Subject: MHI's Response to US-APWR DCD RAI No.779-5865 Revision 3 (SRP 09.04.03)

Response to Request for Additional Information
No. 779-5865, Revision 3

RAI NO.: 779-5865 REVISION 3
SRP SECTION: 09.04.03 – AUXILIARY AND RADWASTE AREA VENTILATION SYSTEM
APPLICATION SECTION: DCD Section 9.4.3
DATE OF RAI ISSUE: 7/11/2011

Figure 9.4.3-1 Auxiliary Building HVAC System Flow Diagram

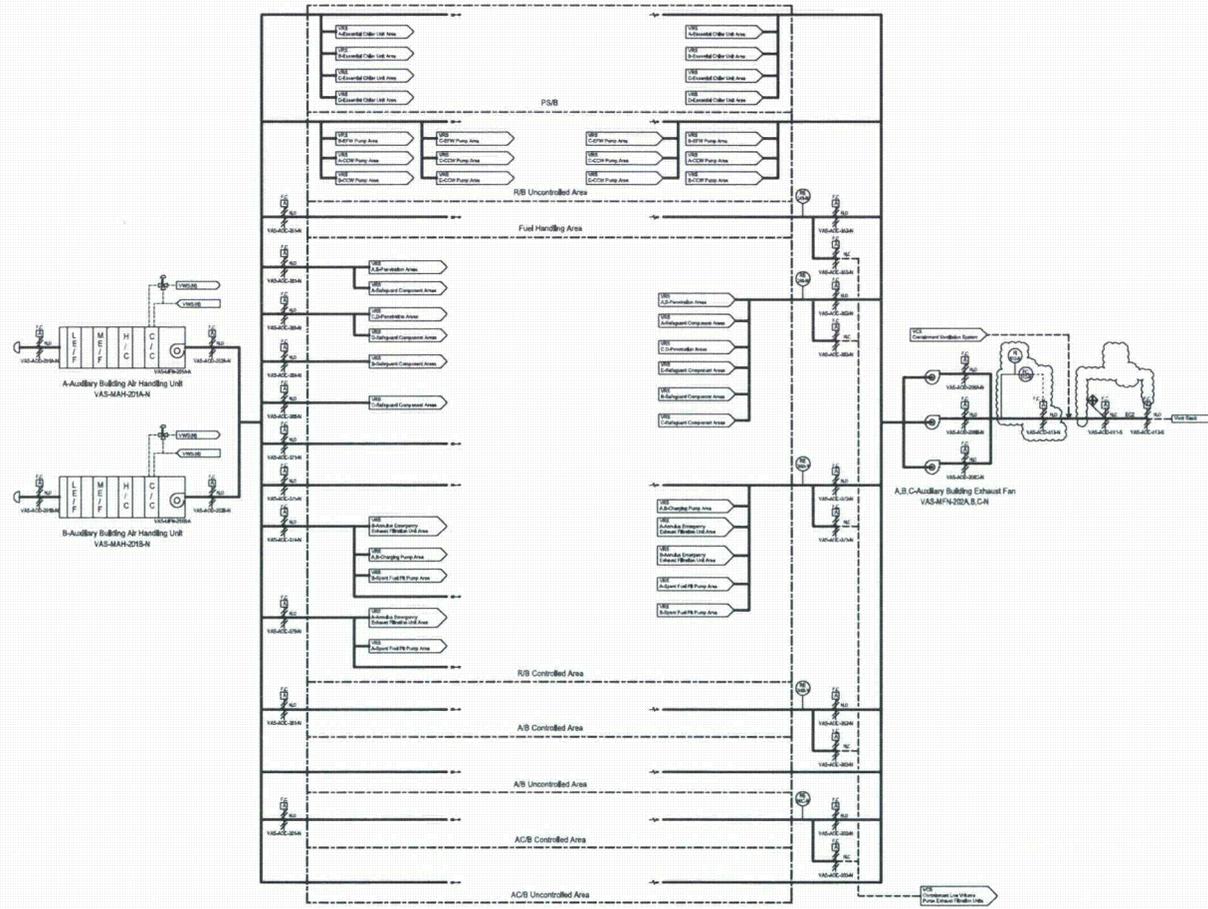
To prevent the backflow of Containment air into the controlled and noncontrolled areas of the Auxiliary Building via the containment low volume purge system, the staff requests additional clarification (reference FSAR Figures 9.4.3-1 and 9.4.6-1).

In addition, the applicant's response to Part 2 of question 09.04.03-13 included the words "backdraft dampers installed at penetrations between controlled and clean areas prevent ventilation backflow from potentially contaminated areas." The staff notes that Figure 9.4.3-1 does not display these backdraft dampers and DCD Section 9.4.3 "Auxiliary Building Ventilation System" does not discuss the existence of the dampers. The staff requests that the applicant revise both DCD Section 9.4.3 and Figure 9.4.3-1 to include a discussion and representation of these backdraft dampers.

As shown in attachment-1, flow damper VAS-AOD-513-N will be installed to adjust the ABVS exhaust airflow rate to design flow rate described in DCD Subsection 9.4.3.2.1 regardless of the operation of HVCP and LVCP. HVCP does not operate under 2 psig containment pressure plus the pressure developed across the fan since HVCP operates during the refueling condition. During the operation of LVCP under the condition, the ABVS provides the design exhaust air by the adjustment of the flow damper VAS-AOD-513-N. Therefore, there is no airflow from HVCP and LVCP to ABVS under the condition.

As indicated in the response to Question No.9.4.3-15, DCD Subsection 9.4.3.2.1 will be revised to describe the backdraft dampers. This level of detail is not shown in the simplified flow diagram in DCD Figure 9.4.3-1.

DCD Figure 9.4.3-1 will be revised as shown in attachment-1.
